工程指示 / 要求簡箋(E.I.)

工程指示編號：EI / 1541 / 20

工程名稱：觀塘裕民坊

工程項目：後裝窗 T2,28/F 防火窗改 ACCESS PANEL

T2 28/F Access Panel

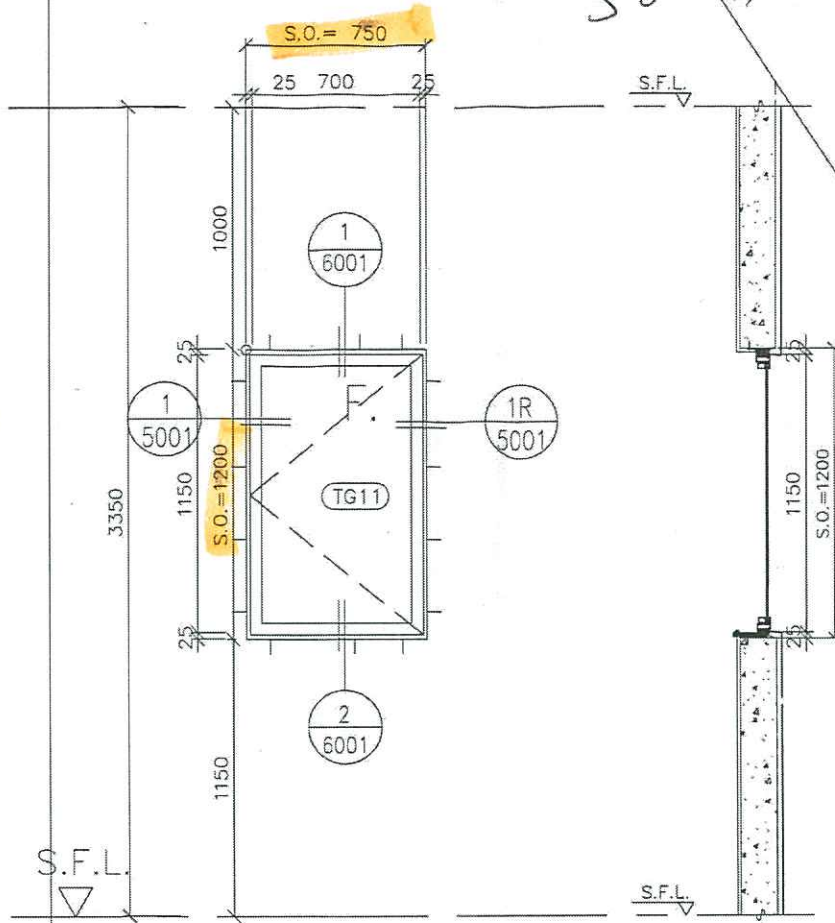
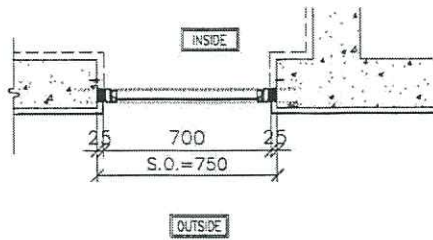
按則師 comment 修改，防火窗改做 access panel

clear opening > 400W  
> 900H

To end this issue, enlarge the S/O until it achieved Min 400mm clear width x 900 mm high without demounted the window sash.

CR please coordinate with midi for the builders work for the required size. Also there shall be an 1 hr FRR board In front of the window (same as other D20 access panel principle).?Please coordinate regarding the window handle without any clashes.

B 版: 放行，確認 SO：750 寬 x 1200 高

S.O. 750x1200H

Dear Christina, Karl  
 ?  
 To achieve Min 400mm clear width x 900 mm high without demounted the window sash, the SO (750 Wx1200 H) for the access panel at T2 28/F was revised for your reference.

T2 - 28F PLAN

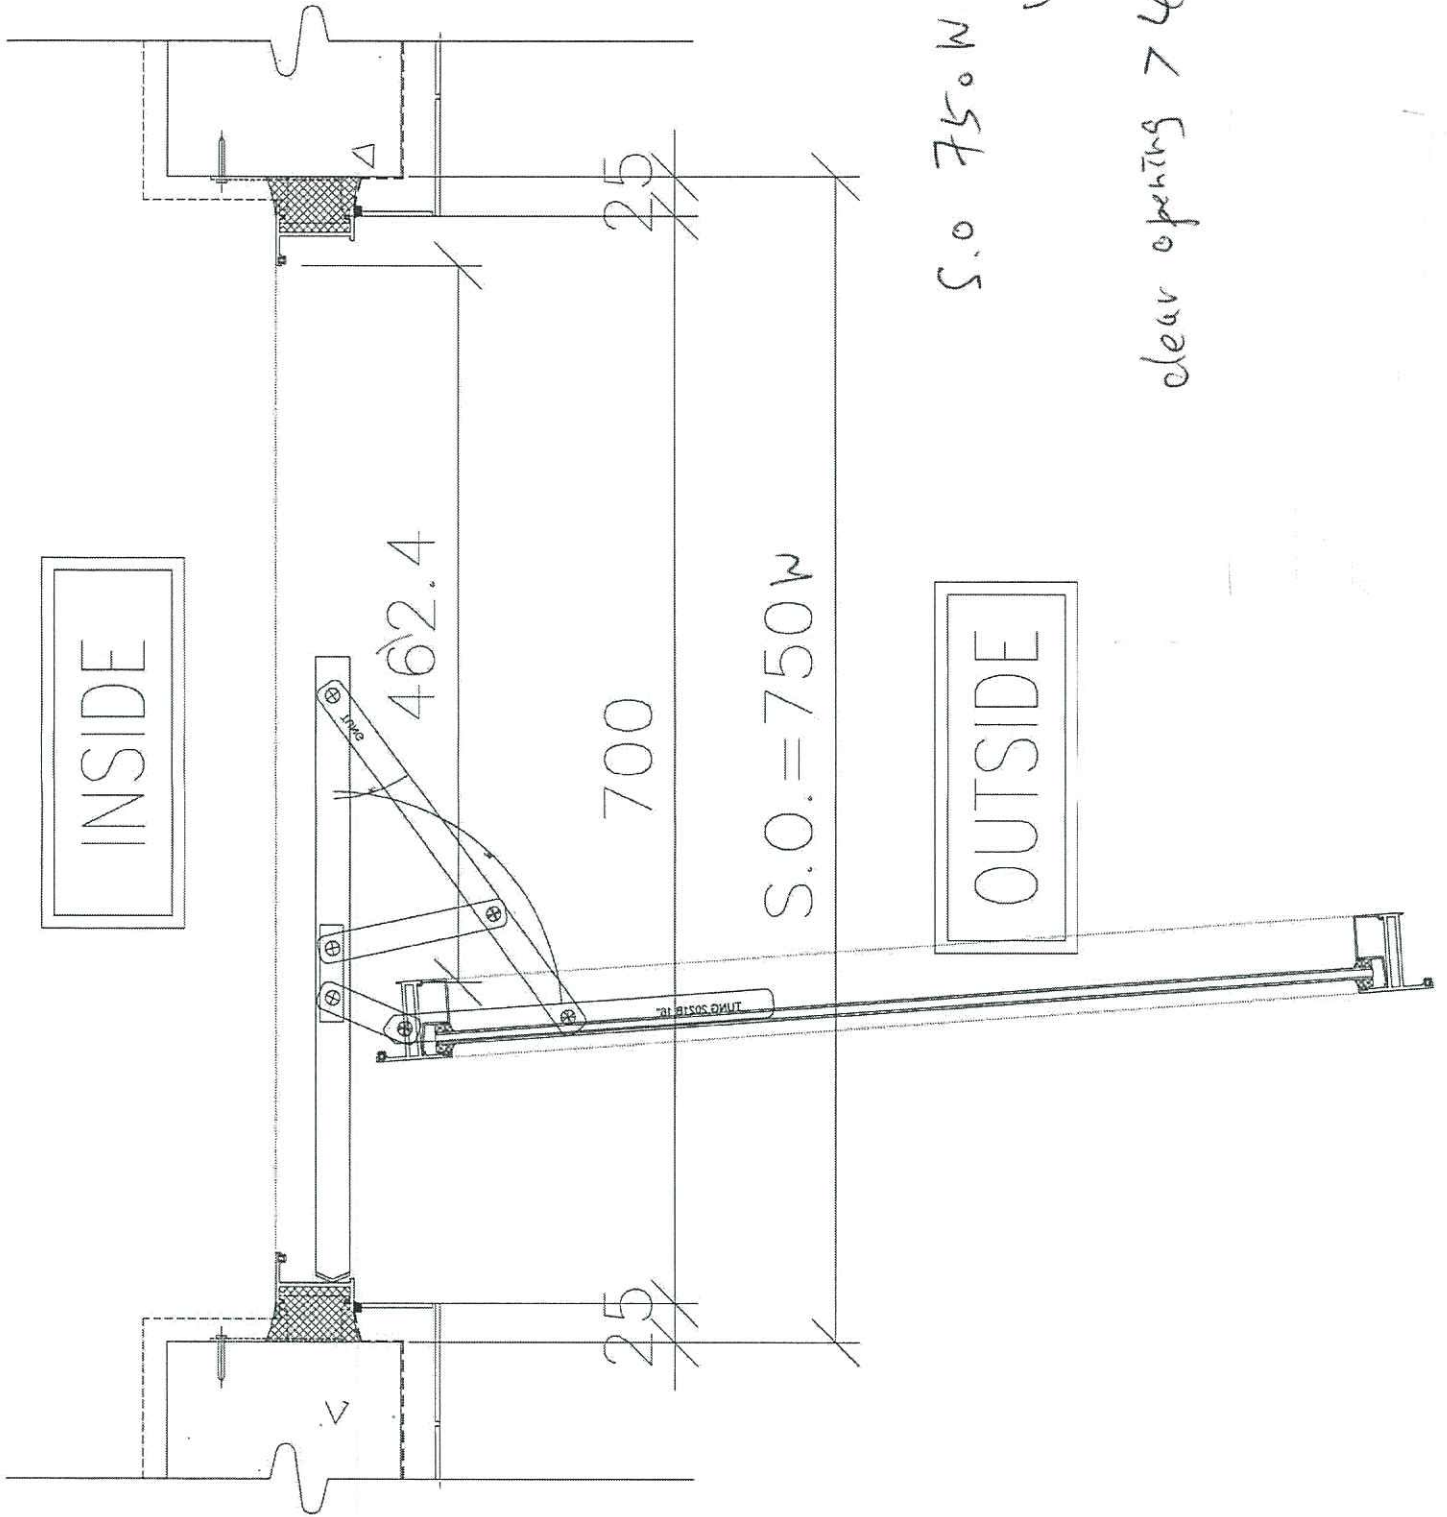
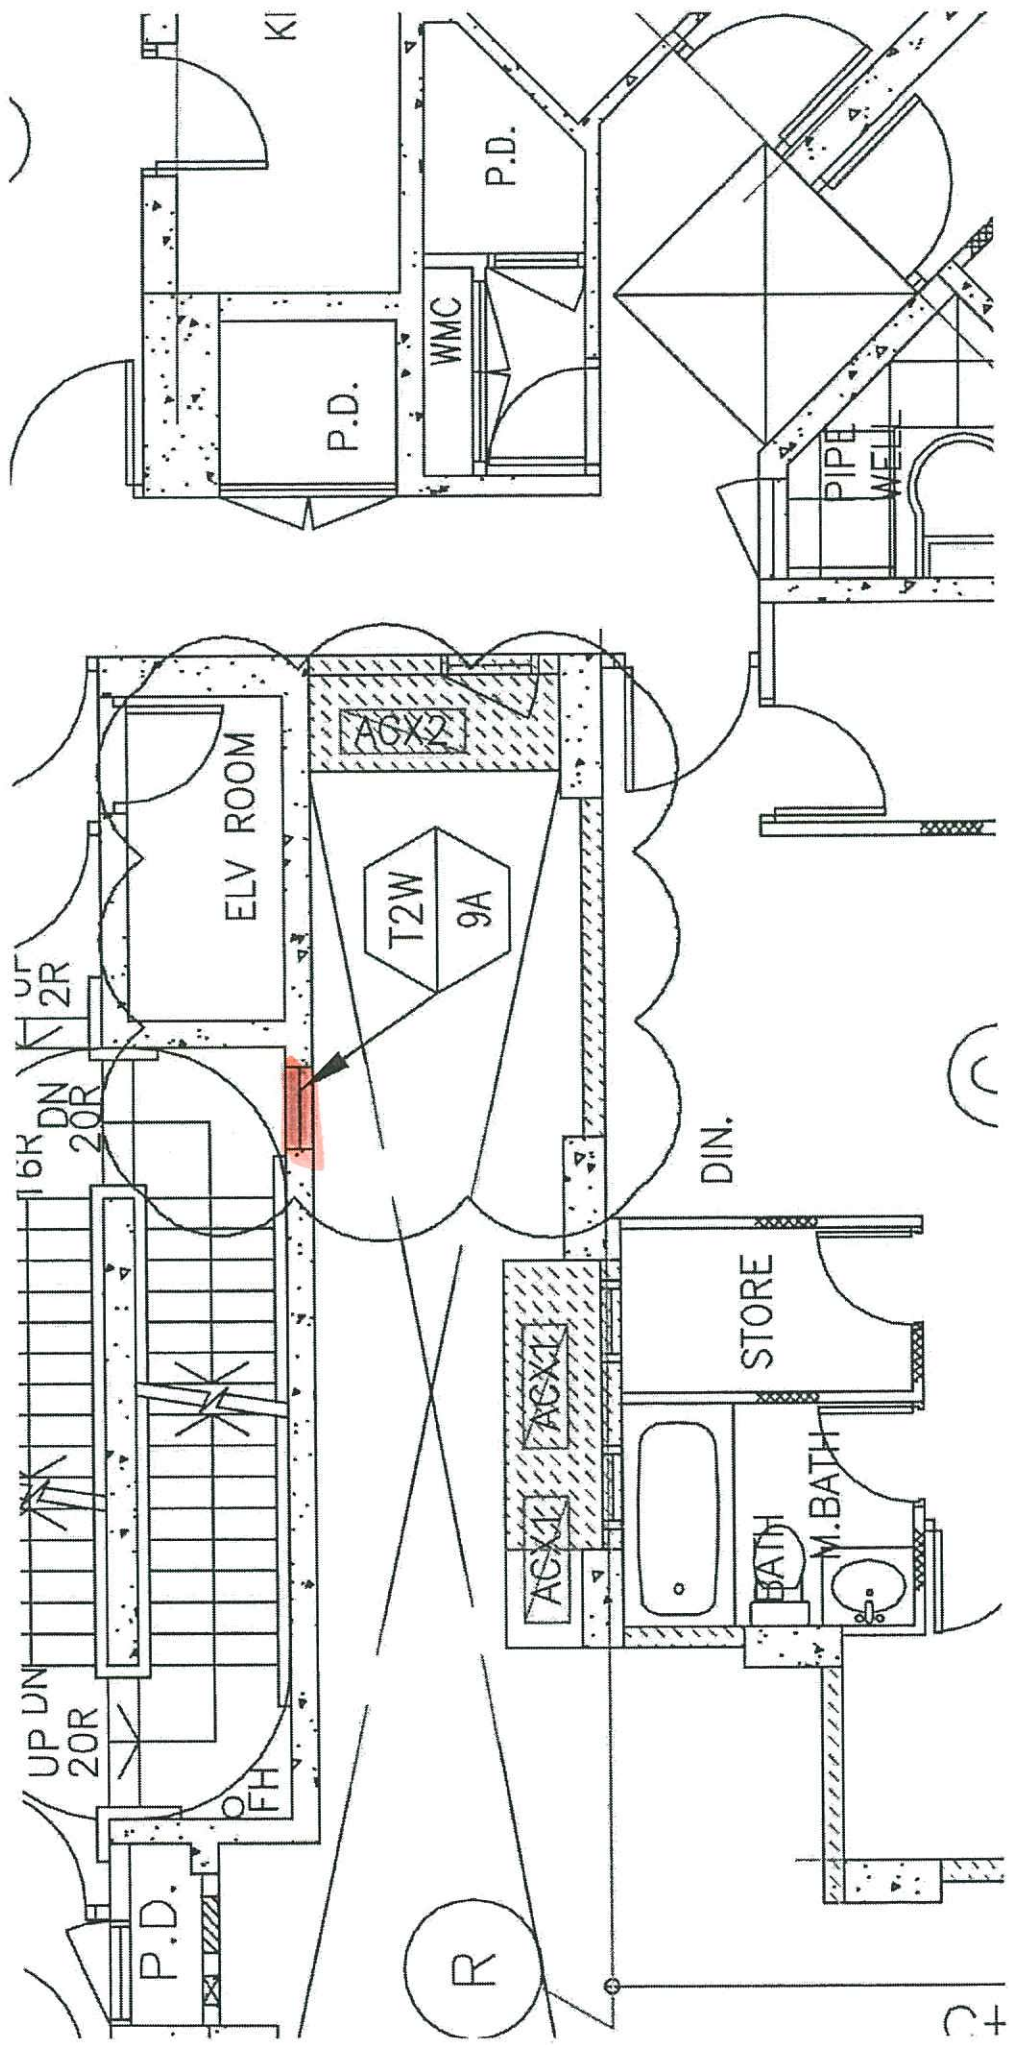
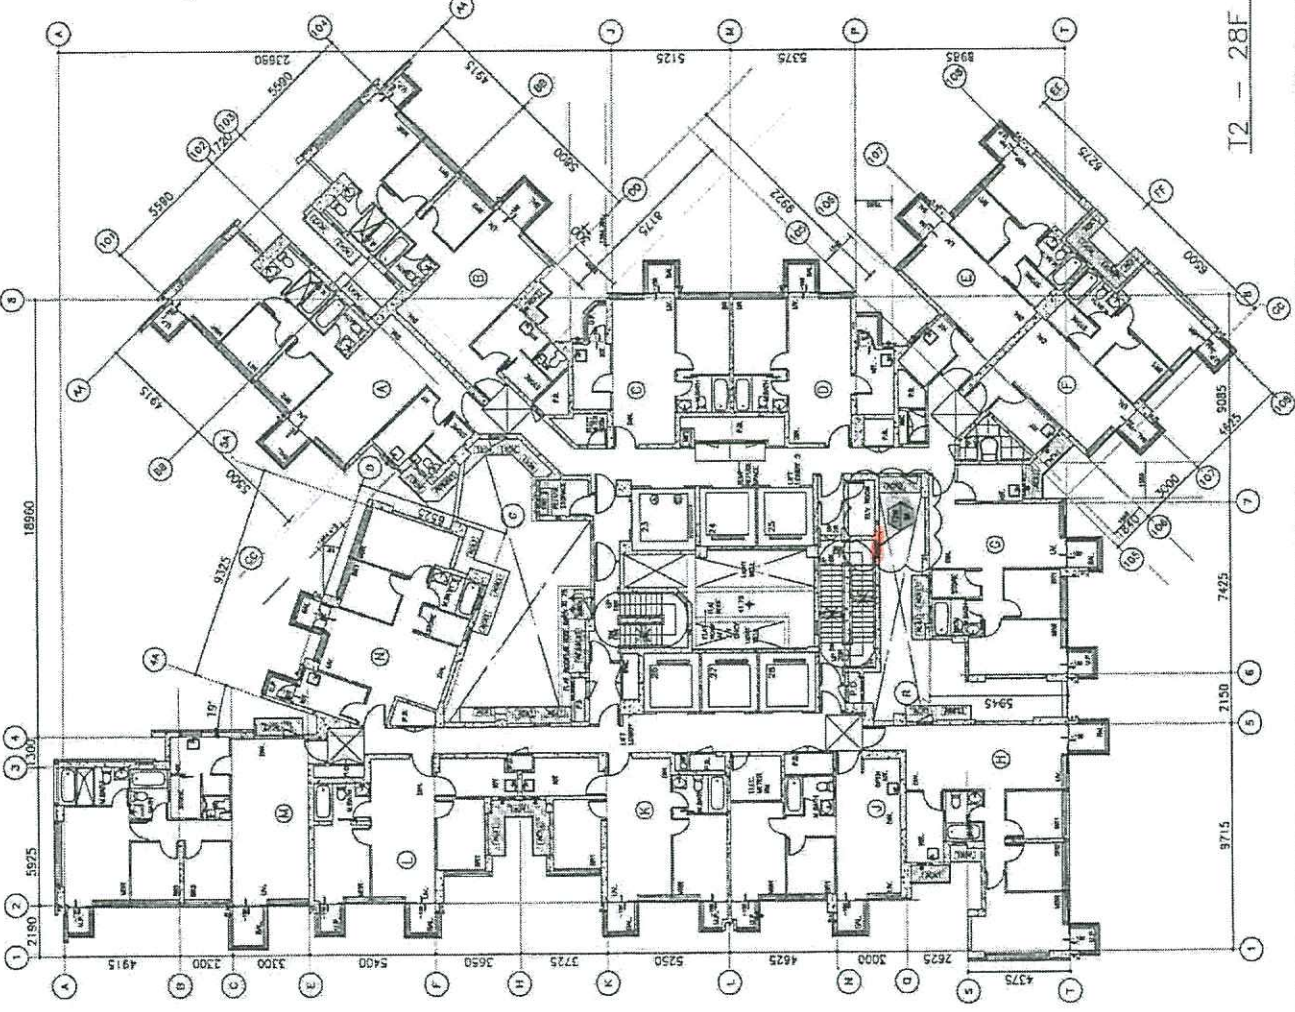
50mm ALUM. SECTION
1 NOS. (TYPICAL)
T2 28/F COMMON CORRIDOR
MIN. 8mm THK ACID ETCHED FROSTED TEMPERED GLASS
